Access Compliance Report

Public Rights-of-Way

Intersection ID: 12721	Main Street: S_CHURCH_ST	Cross Street: W_HILL_ST	Location: W
ADA ID: E8C011044CB2	Ramp Type: Perp	Initial Pass/Fail: Fail	Overall Compliance: No
			Severity Score: 50

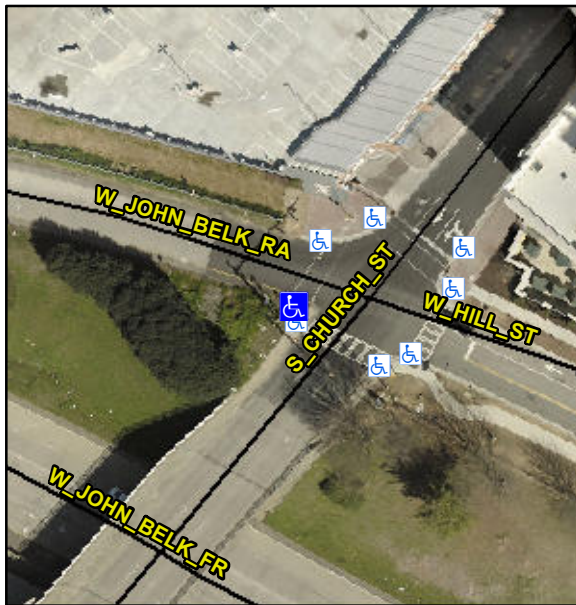
Not Found, R304.2.2, R304.5.3

Compliance	Description	Data	Compliance	Description	Data
N/A	Ramp Length (in)	64.0	No	Ramp Slope (%)	14.2
Yes	Ramp Width (in)	58.0	No	Ramp XSlope (%)	11.2
N/A	Flare Type LT	N/A	N/A	Flare Type RT	N/A
N/A	Flare Slope LT (%)	N/A	N/A	Flare Slope RT (%)	N/A
N/A	Flare Traversable LT?	N/A	N/A	Flare Traversable RT?	N/A
N/A	Landing Length (in)	N/A	N/A	DWS Provided?	N/A
N/A	Landing Width (in)	N/A	N/A	DWS Contrast?	N/A
N/A	Landing Slope (%)	N/A	N/A	DWS Length (in)	N/A
N/A	Landing X Slope (%)	N/A	N/A	DWS Full Width?	N/A
N/A	Landing Curb? (Y/N)	N/A	N/A	DWS Offset (in)	N/A
N/A	Shared Landing?	N/A			
N/A	Gutter Ponding?	N/A	N/A	Gutter Slope (%)	N/A
N/A	Gutter Lip Ht (in)	N/A	N/A	Gutter X Slope (%)	N/A
N/A	Painted X Walk1?	No	N/A	Painted X Walk2?	N/A
	X Walk 1 Direction	To NE		X Walk 2 Direction	N/A
N/A	X Walk 1 Width (in)	N/A	N/A	X Walk 2 Width (in)	N/A
	X Walk 1 Slope (%)	3.4		X Walk 2 Slope (%)	N/A
	X Walk 1 X Slope (%)	7.1		X Walk 2 X Slope (%)	N/A

Remove & Replace Entire Ramp.
